WILWAUKEE   HISTORIC   PRESERVATION   LIVING WITH HISTORY	
Property	1501 N. MARSHALL ST. Graham Row
Description of work	
Date issued	6/14/2017   PTS ID   114293 COA: heat pump
In accordance with the provisions of Section 320-21 (11) and (12) of the Milwaukee Code of Ordinances, the Milwaukee Historic Preservation Commission has issued a certificate of appropriateness for the work listed above. The work was found to be consistent with preservation guidelines. The following conditions apply to this certificate of appropriateness: <u>1.</u> Building wall may be punctured only once in the location shown and no other punctures may be created.	
<u>2.</u> No exterior linesets may be used. All equipment except heat pump coil unit must be interior. <u>3.</u> Condenser unit may not extend past west wall of building <u>4.</u> Permission is additionally required from the condo association.   5. Electrical outlet attachments may be drilled only into mortar and not into brick or stone.

Marshall façade

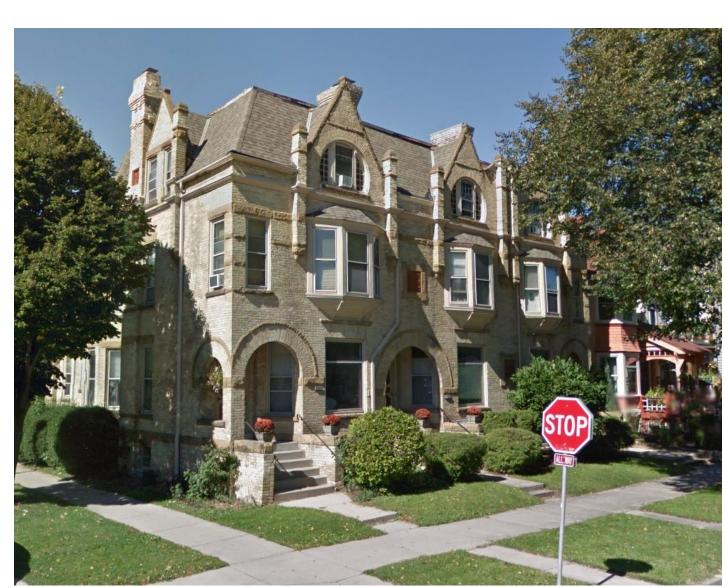
Location of unit must be behind shrubs in white boxed area an may not extend past west wall of building, excluding stoop and basement doors.

## E. Lyon St. façade.

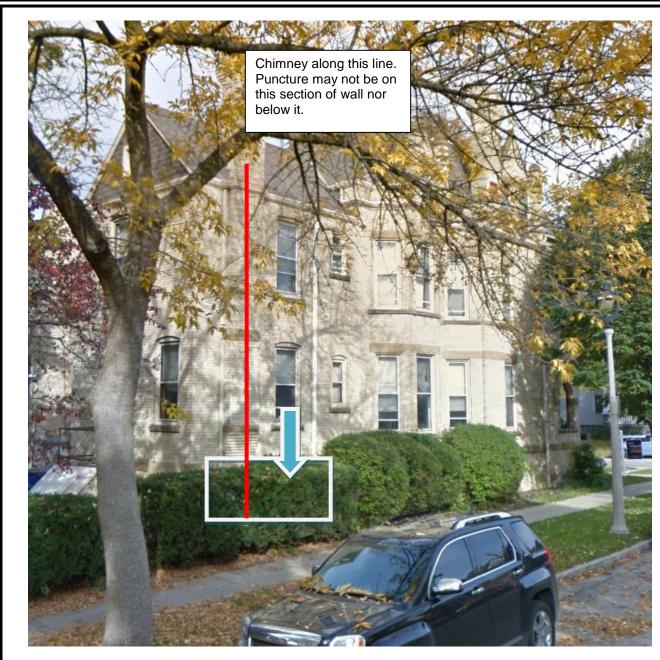
Puncture of wall may not pass through line of chimney.

Wall puncture and electrical outlet shall be below area marked with arrow, under window and as close to grade as feasible. Attachments for electrical outlet must be drilled only into mortar and not brick or stone.
